Item 6.1.1.1: ERCOT Comments on NPPR 1186

Reliability and Markets Committee Meeting

October 16, 2023

ECRS State of Charge Requirement for 50MW - Current Version

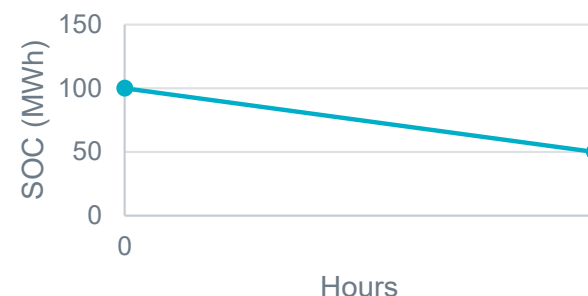
- ERCOT submitted comments to the Board-remanded version of NPRR1186 to change the minimum State of Charge (SOC) requirements for ECRS and Non-Spin to slope from the full hourly Ancillary Service (AS) Resource Responsibility at the start of each hour to 0 MWh at the end of the hour in each hour where the Resource is carrying that Responsibility.

- **Example:** To provide 50 MW of ECRS, the minimum SOC requirement will be 50 MWh at the top of the hour and will decrease as a function of time to 0 MWh by the end of the hour.

- This change eliminates the need for ESRs to hold any more SOC than the amount needed for a full deployment across a single hour and will enable this energy to be made available to the grid in all conditions, including scarcity.

- This approach, however, does increase the risk that an ESR that is planned to carry an AS in a future hour will not achieve sufficient SOC by that hour to provide the service. ERCOT is proposing one or more forthcoming NPRR(s) to add controls to mitigate this reliability risk.
